May 9, 2018

***Subject: Traffic Report for the Proposed Residential Project at 4856 & 4846
El Camino Real, Los Altos***

Hexagon Transportation Consultants, Inc. has completed this traffic report for the proposed residential project at 4856 & 4846 El Camino Real, Los Altos (see Figure 1). The project is proposing a total of 50 condominium units, including 9 one-bedroom units, 30 two-bedroom units, and 11 three-bedroom units. The project proposes 108 parking spaces.

Figure 2A

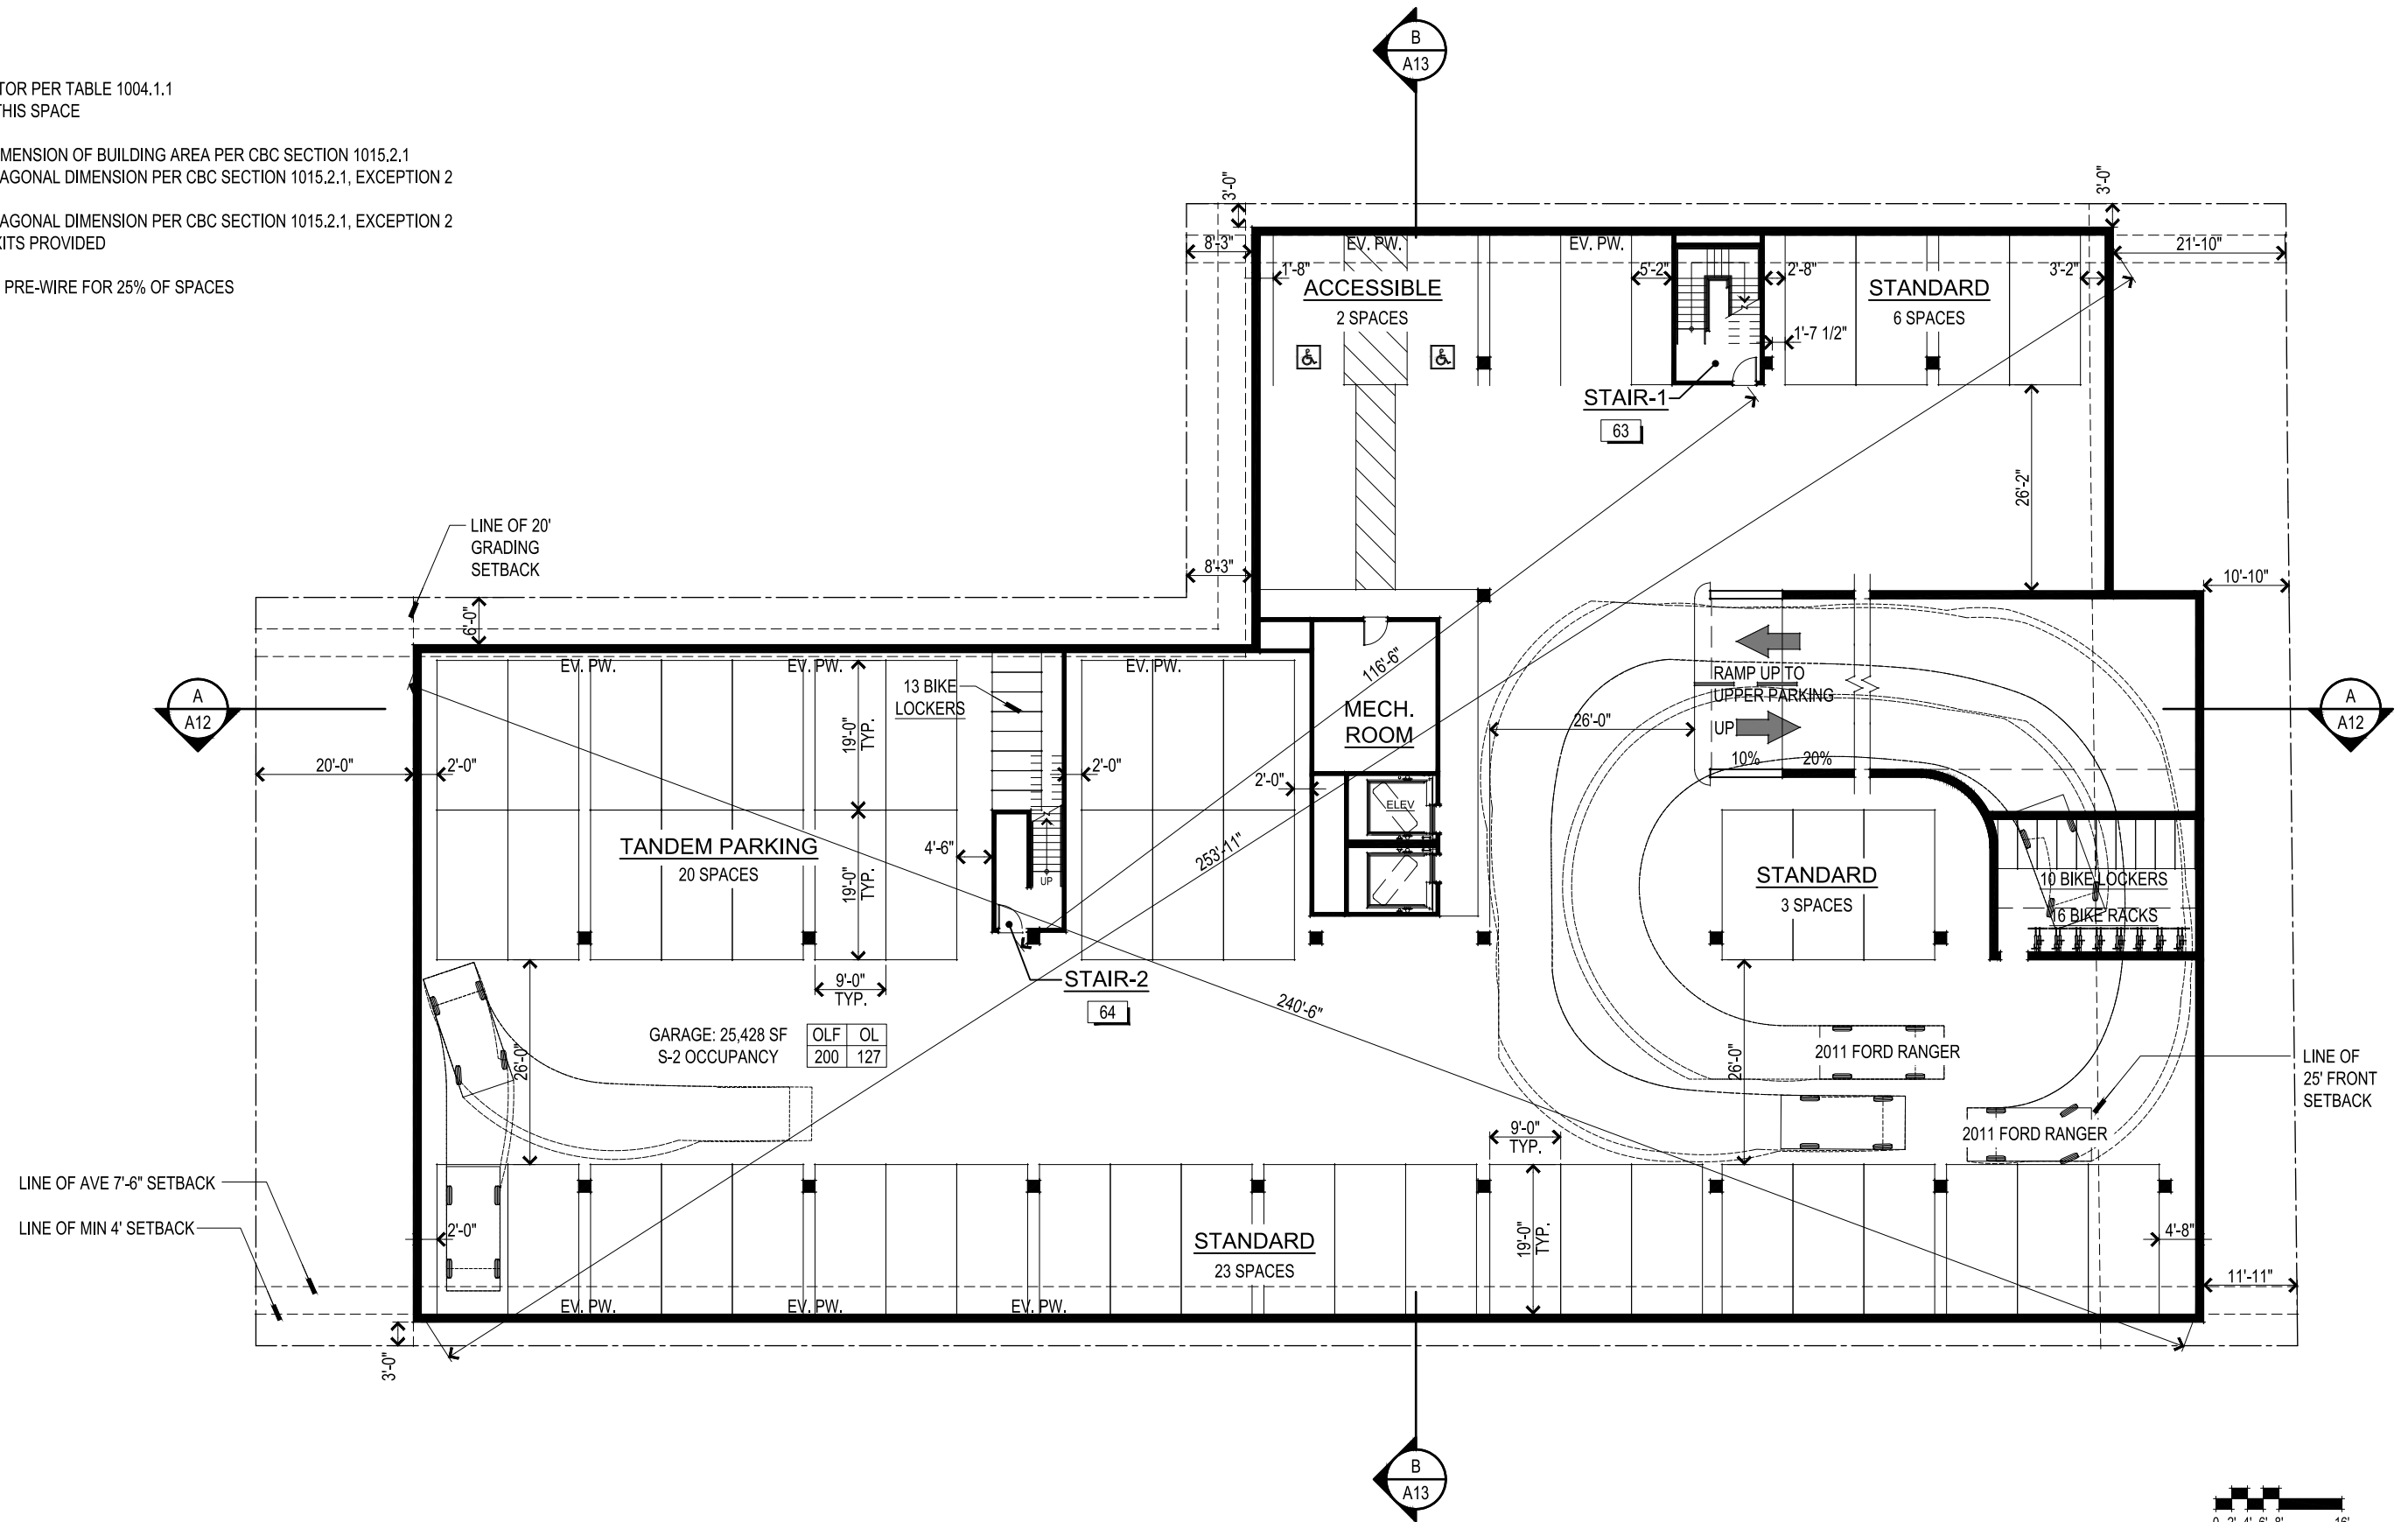
Garage Design. On each level of the parking garage, there are two sections of parking: to the east of the ramp and to the west of the ramp. On both sides parking would be provided at 90 degrees to the main drive aisle. The drive aisles through the parking garage are shown to be 26 feet wide, which would provide sufficient room for vehicles to enter or back out of the 90-degree parking stalls, including the tandem stalls. Site access and circulation were evaluated using AutoTurn with vehicle turning movement templates for a typical AASHTO Passenger Car defined in AASHTO handbook 2011. Some examples of this type of vehicles are: 2018 Cadillac Escalade, 2018 GMC Yukon, 2018 Chevrolet Suburban, 2018 Ford Expedition, and 2018 Toyota Sequoia. The turning template check shows that large passenger vehicles would be able to access, circulate, and exit the garage without operational issues. The turning template check also indicates that vehicles would be able to access and exit from the parking spaces at the end of the drive aisle that are adjacent to the rear basement walls on each level without operational issues (see Figures 2A and 2B).

- The proposed plan shows good circulation through the two levels of the garage. The drive aisle is shown to be 26 feet wide and would provide sufficient room for vehicles to back out of the 90-degree parking stalls including the tandem stalls. The vehicle turning paths are constrained by the inner wall of the ramp at both ends under the current design. Hexagon recommends the design be revised to move back the wall to provide enough spaces for vehicles to make turns to and from the ramps.

- There are some places in the garage where visibility would be limited. . Hexagon recommends that convex mirrors be placed at all locations in the garage where visibility is limited.

Figure 2B
UPPER LEVEL BASEMENT FLOOR PLAN

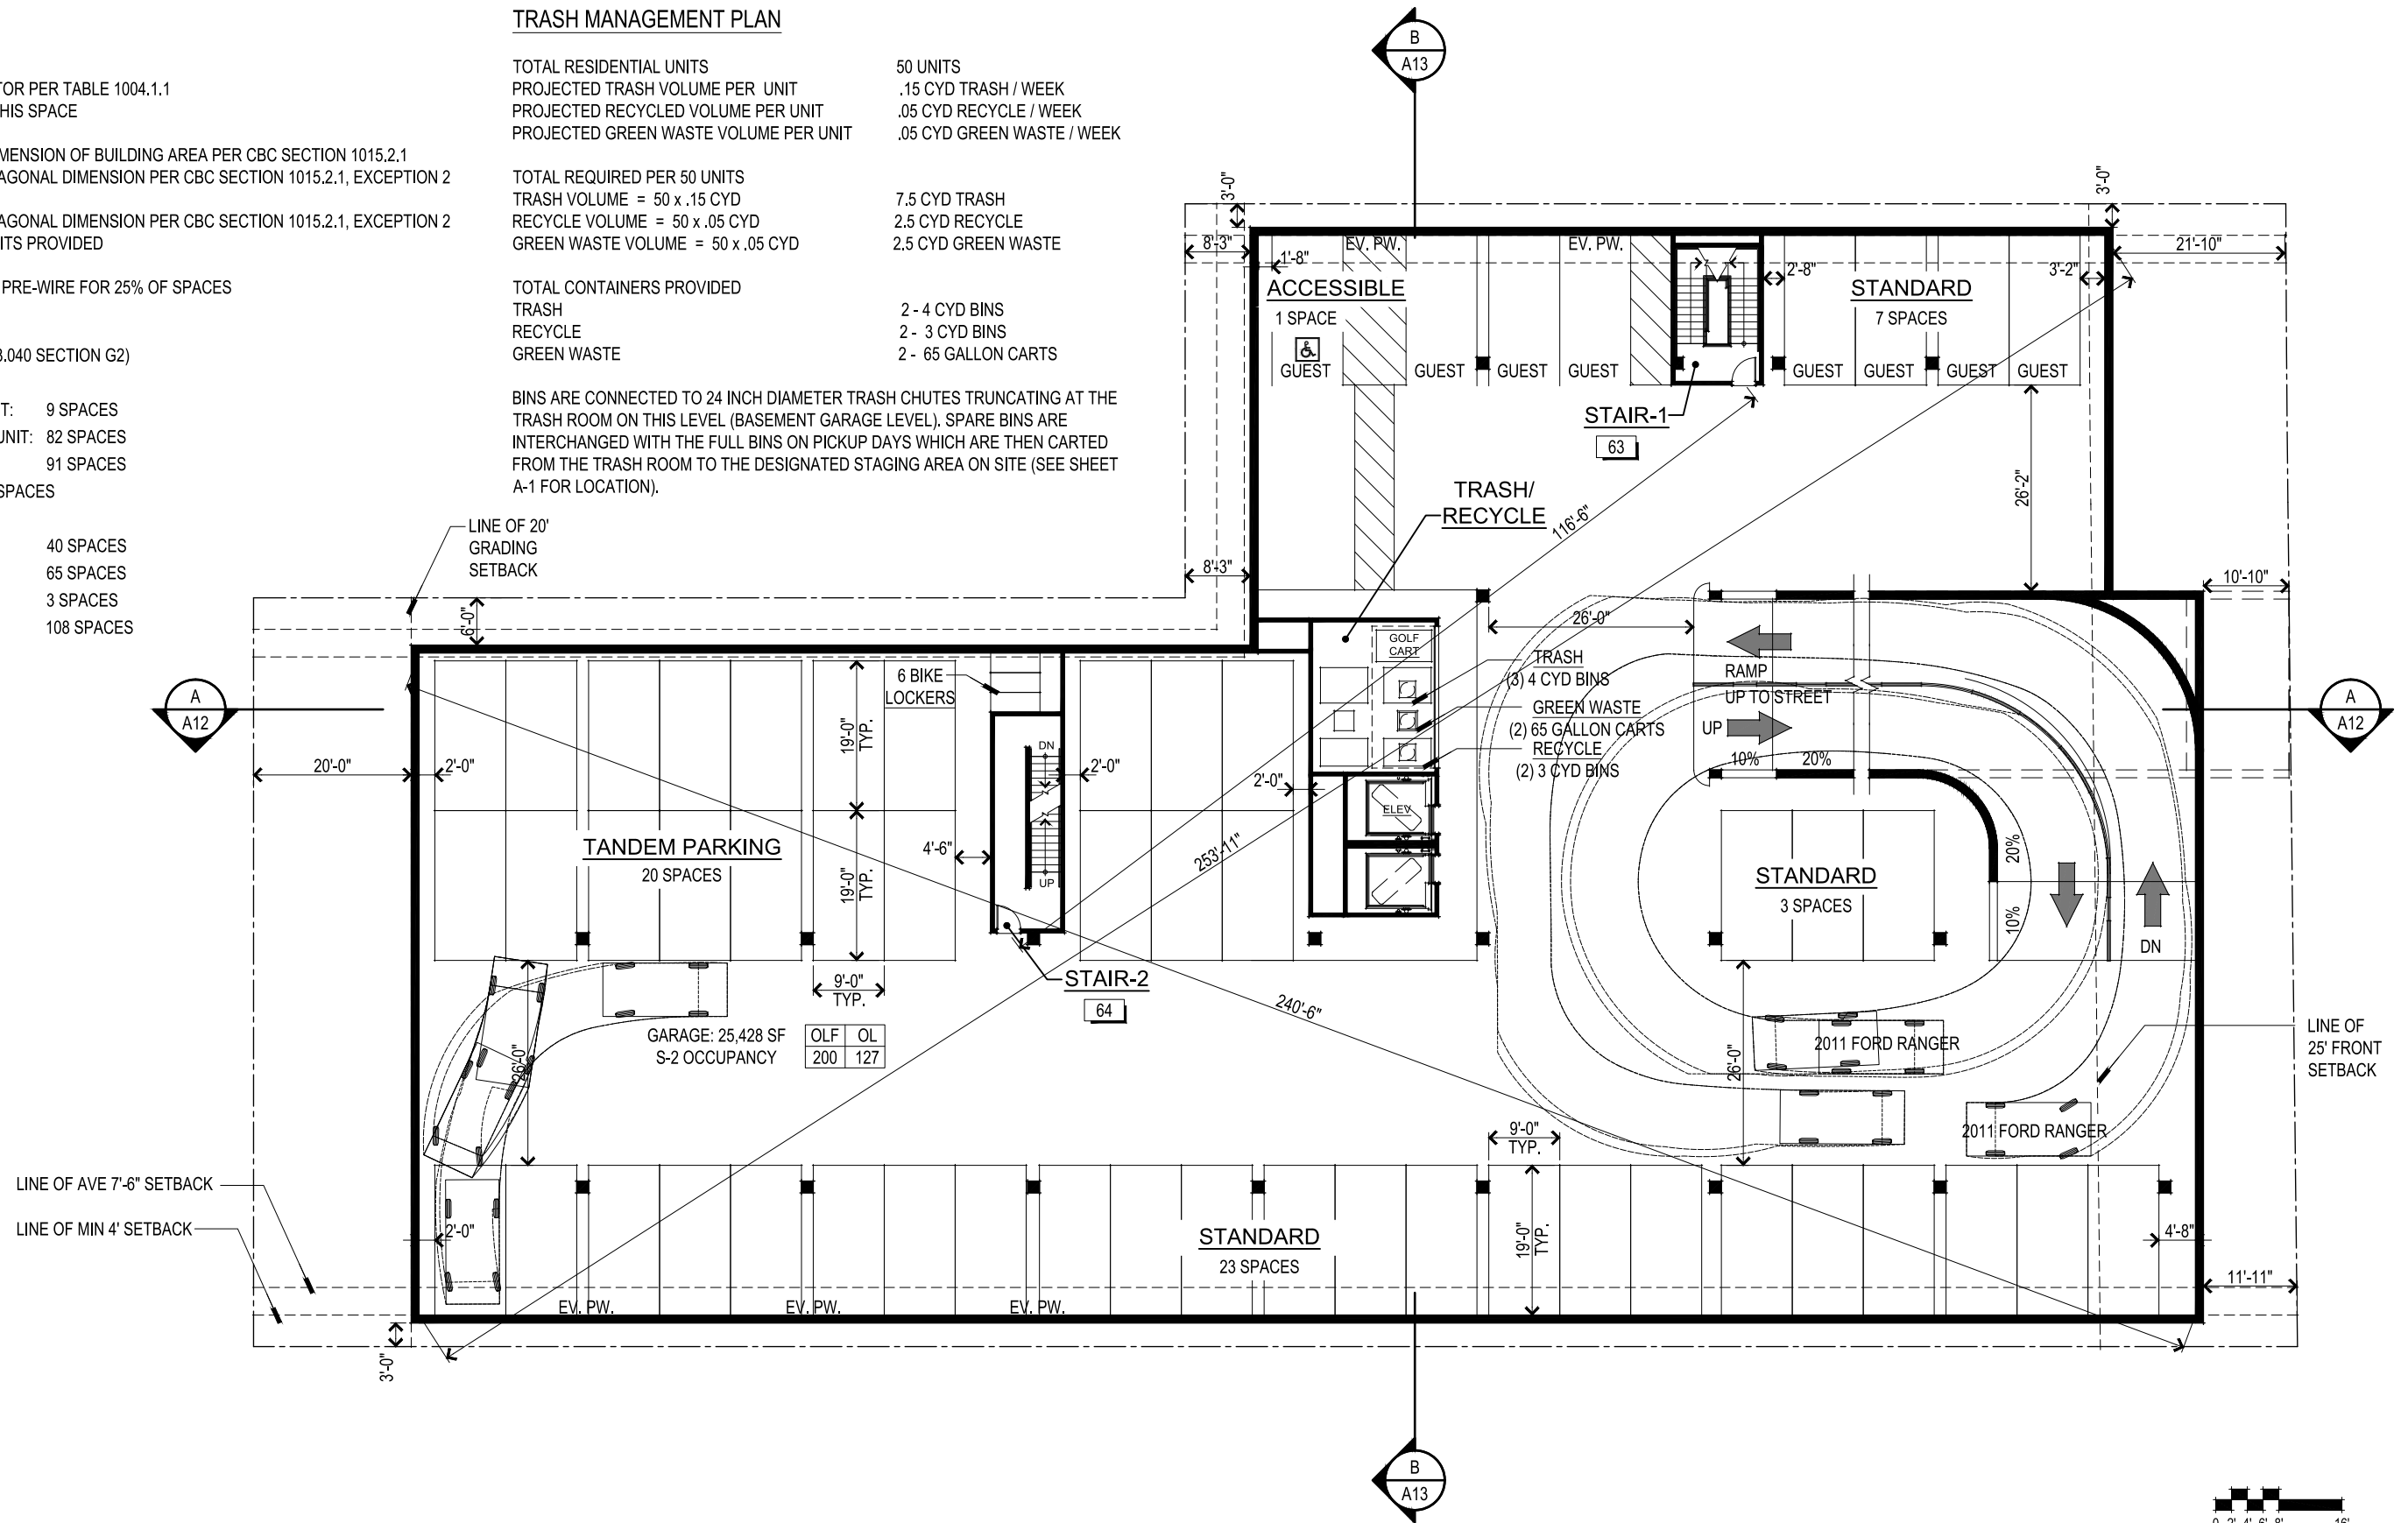
The plan shows guest parking spaces to the east of the garage ramp on the upper level of the garage. There should be signage directing guests to these parking spaces. The guest parking area has dead-end aisles, but they are very short, so motorists would be able to

see if there were any available spaces. Guests finding no available spaces would be able to exit the parking garage relatively easily. The resident parking area also has dead-end aisles, but residents would be familiar with the garage operations and would know where to find available spaces. There are some places in the upper level of the garage where visibility would be limited where the ramps and aisles turn corners. Vehicles parked on the parking spaces located opposite the entrance to the lower level ramp would need to be careful and pay attention to vehicles driving towards the ramps when backing out of those spaces. Hexagon recommends that convex mirrors be placed at all locations in the garage where visibility is limited.
